This is to certify that FRIEDMAN MARIAN T & ESTHER S JTShas permission to infill addition & interior remodel Phase 2AT 549 ISLAND AVE PEAKS ISLAND

Location of Construction: 549 ISLAND AVE PEAKS ISLAN	Owner Name: FRIEDMAN MARIAN T & ETALS	Owner Address: 401 CUMBERLAND AVE # 1406	Phone:
Business Name:	Contractor Name: John Kiely	Contractor Address: 591 Island Ave Peaks Island	Phone: 2077662026
Lessee/Buyer's Name	Phone:	Permit Type: Additions - Dwellings	Zone: IR-2

Dept: Zoning **Status:** Approved with Conditions **Reviewer:** Ann Machado **Approval Date:** 01/16/2009
Note: **Ok to Issue:**
1) This property shall remain a single family dwelling. Any change of use shall require a separate permit application for review and approval.
2) This permit is being approved on the basis of plans submitted. Any deviations shall require a separate approval before starting that work.

Site Plan

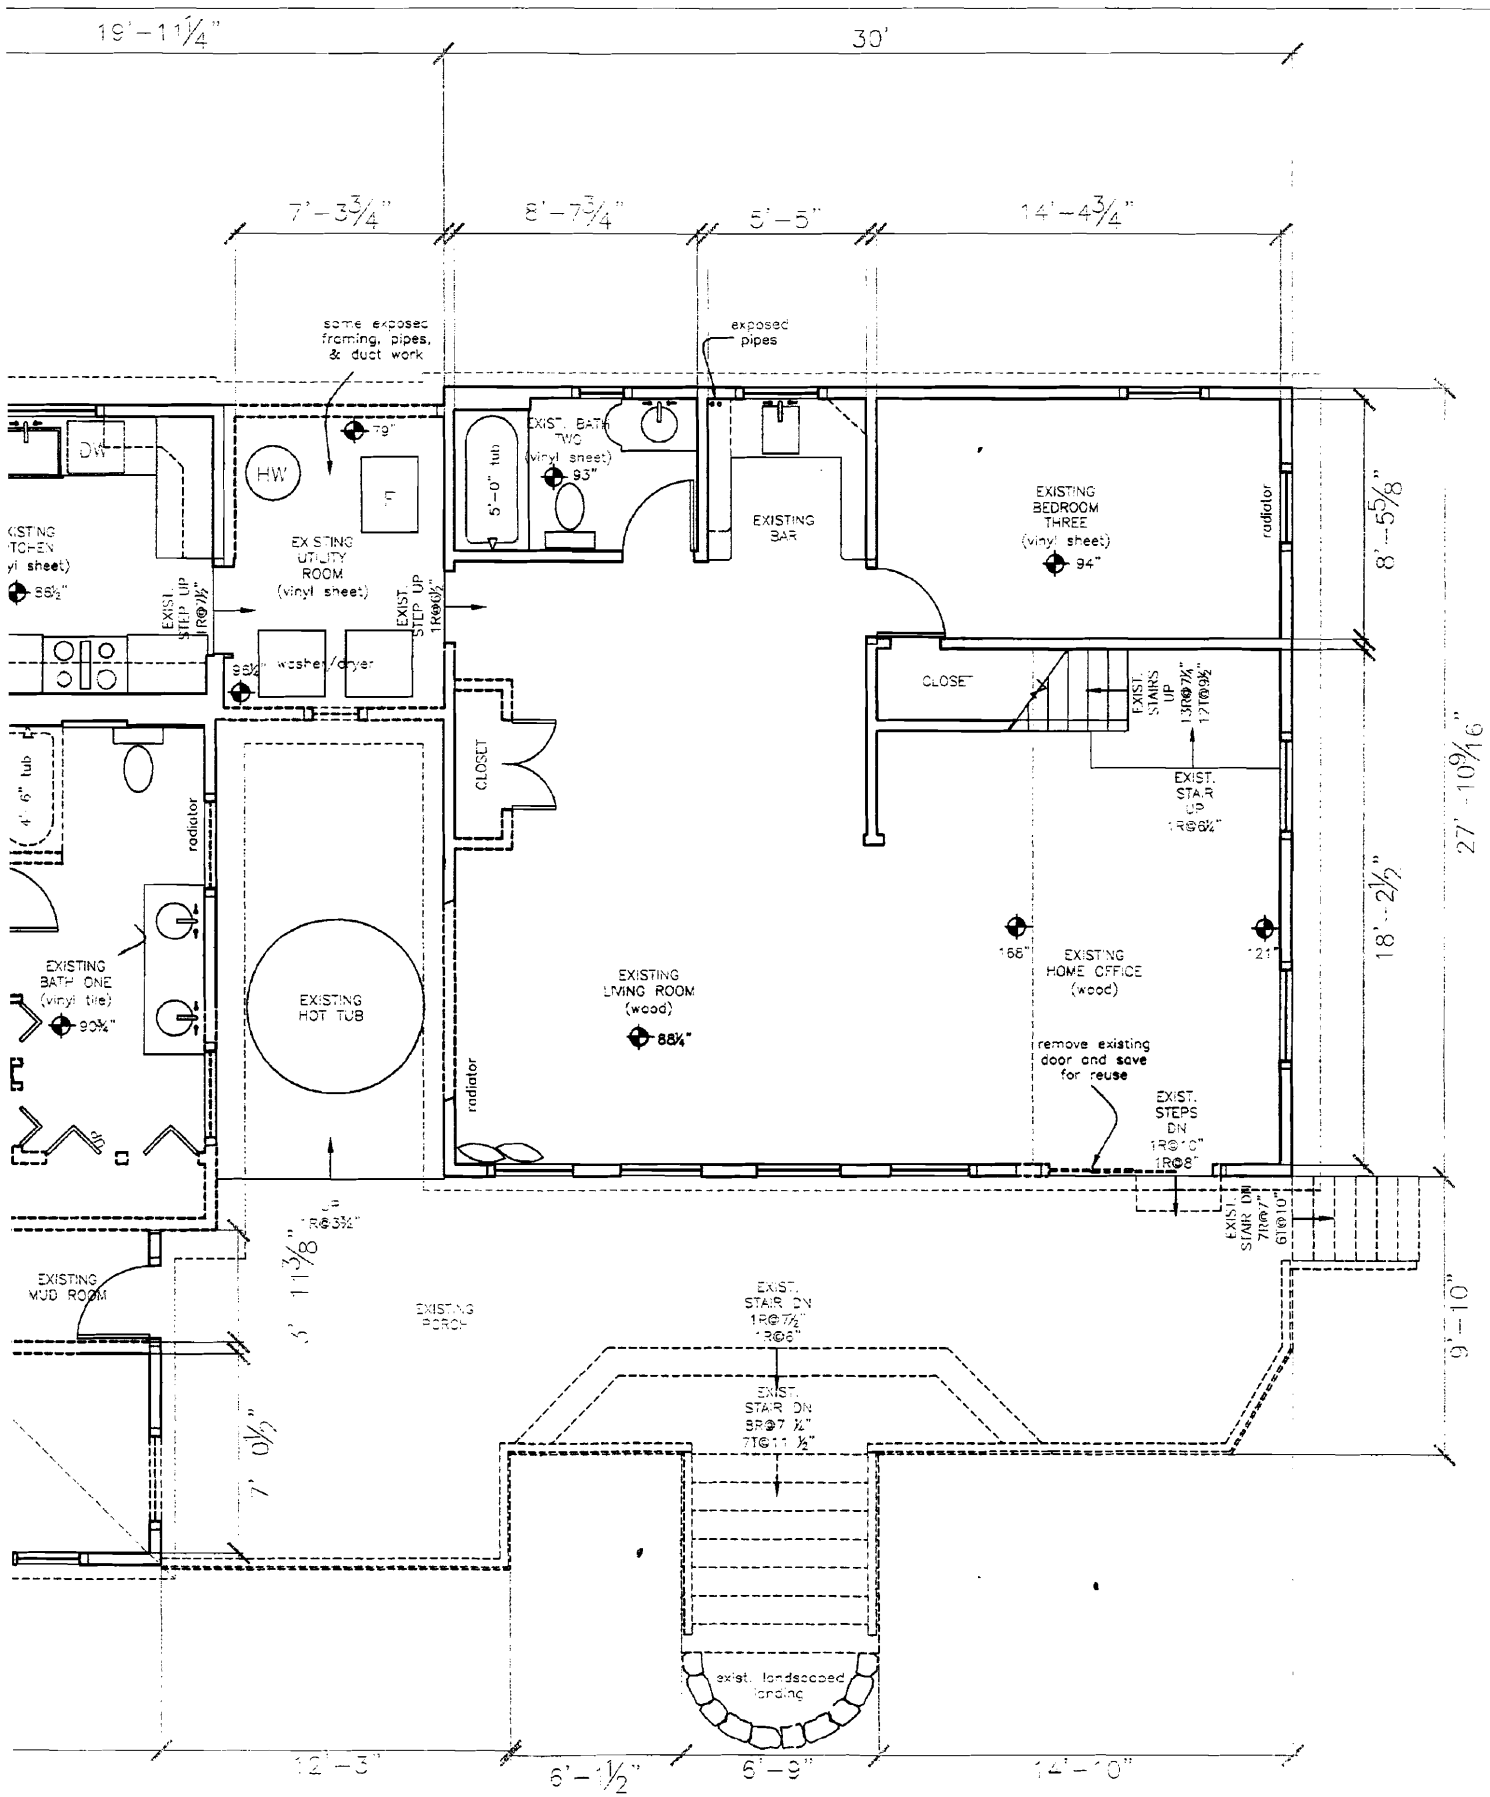
Front Yard - 25' or average $(9.5 + 25 = 34.5 \div 2 = 17.25)$ - 21.5' setback OK.

* 1 story being added is beyond the setbacks.
~~setback~~ ; filling in where existing
story around it. so OK.

Lot Coverage Impervious Surface - 25% = 3293.4 ϕ existing 3080.75 (permit 08-1485)

~~addition~~ no increase in lot front. deck
was already there.

Shoreland Zoning/ Stream Protection - property in 250' setback but well past 75' setback.
